PCN – Product Change Notification

PCN-A-100923

PCN Topic: 20.1" A3 panel (1366x768) will be replaced by 21.6" A2 panel (1366x768).

The below pictures show the example of how the new mechanic differ from Original one.

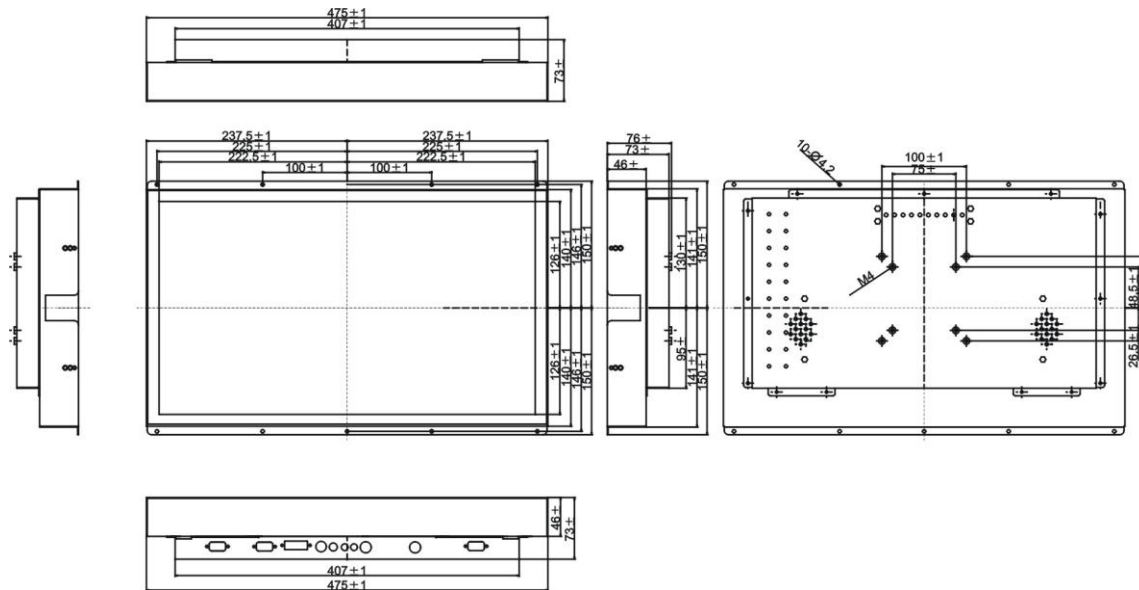
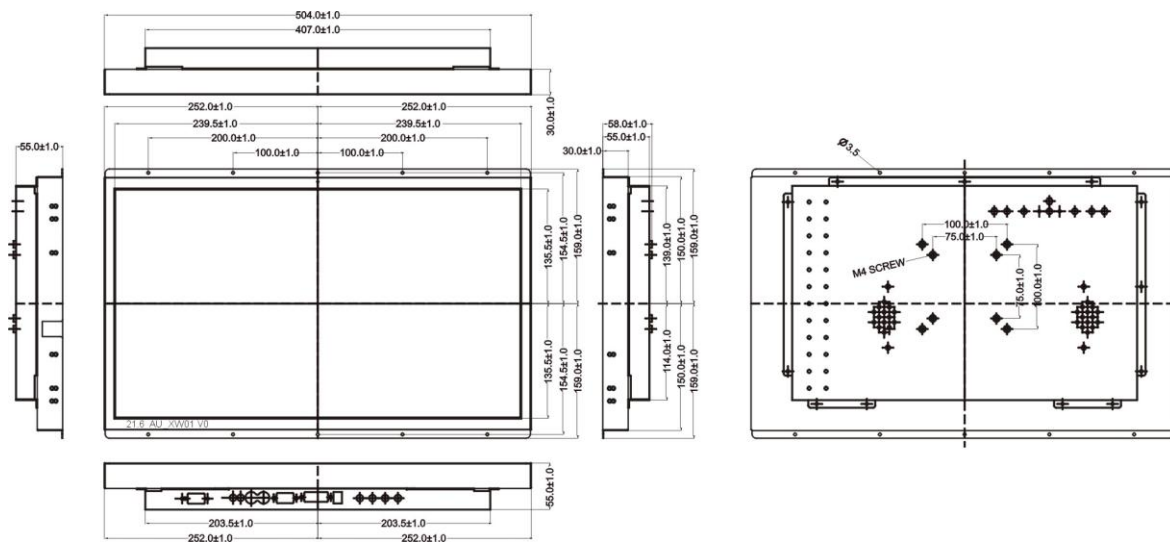
The 20.1" A3 panel (1366x768) is replaced by 21.6" A2 panel (1366x768):

The dimension of open frame mechanical will change from 475 X 300 X 76 mm to 504 X 318 X 58 mm.
